APPLICATION NO.	FILING DATE	FIRST NAMED INVENTOR	ATTORNEY DOCKET NO.	CONFIRMATION NO.
10/748,308	12/29/2003	Seok-Jun Won	9898-304	7991

Office Action Summary

DETAILED OFFICE ACTION

*FIG. 4*

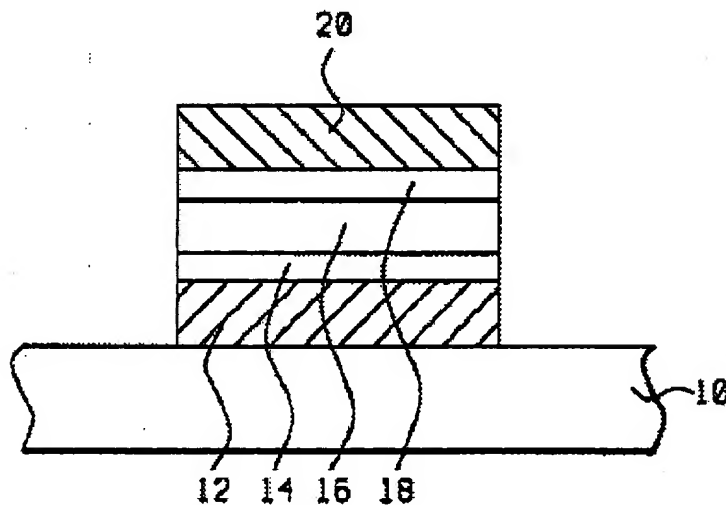
Shih et al. (the title, the abstract, fig 4, paragraph [0022] , paragraph [0023] , paragraph [0024]) disclose a capacitor of a semiconductor device comprising: a capacitor lower electrode

(fig 4 layer 12) disposed a semiconductor substrate; a first dielectric layer (fig 4 layer 14) comprising aluminum oxide disposed on the capacitor lower electrode; a second dielectric layer (fig 4 layer 16) comprising a material having a higher dielectric constant than that of aluminum oxide disposed on the first dielectric layer; a third dielectric layer (fig 4 layer 18) comprising aluminum oxide disposed on the second dielectric layer; and a capacitor upper electrode disposed (fig 4 layer 20) on the third dielectric layer and a method for manufacturing a capacitor of a semiconductor device, the method comprising: forming a capacitor lower electrode on a semiconductor substrate; forming a first dielectric layer comprising aluminum oxide on the capacitor lower electrode; forming a second dielectric layer comprising a material having a higher dielectric constant than aluminum oxide on the first dielectric layer; forming a third dielectric layer comprising aluminum oxide on the second dielectric layer; and forming a capacitor upper electrode on the third dielectric layer.
